Project Addendum No. 4

Project: **Pay Parking Improvements at the
Brownsville S.P.I. Int'l Airport
COB Bid No. PPI-30-0410** Addendum
Date: **April 8, 2010**

This notice serves as Addendum No. 4 to the above referenced project. This addendum addresses items that have been clarified since Addendum no. 3.

HANDICAP SIGN

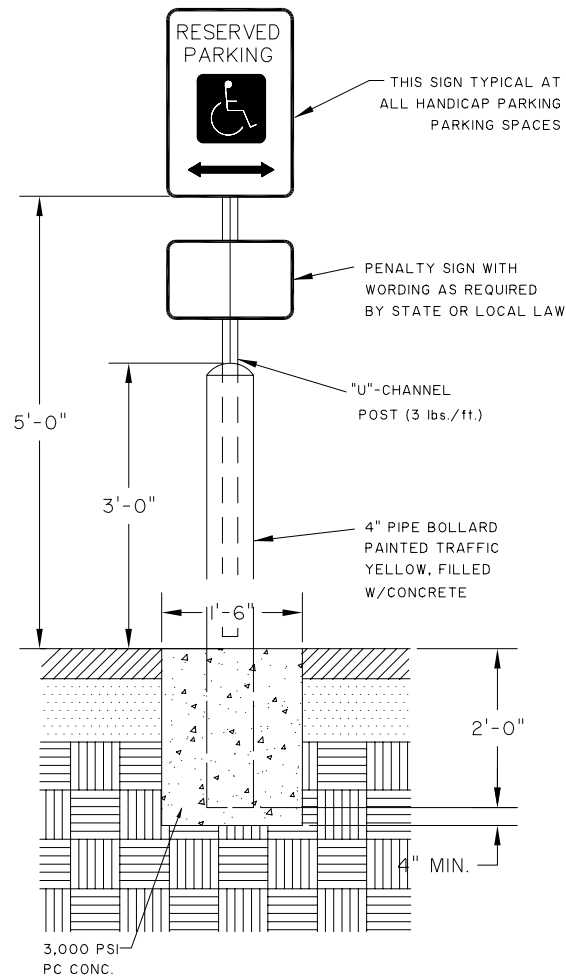
3. Clarification: Details Sheet- On the Typical Pavement Section – the note referring to **4” Caliche** at the bottom of the detail is to be ignored.
4. New Item: Handicap Signs – To be included in this item is the furnishing and installation of 8 standard parking lot handicap signs and assemblies. Detail is provided with this addendum.
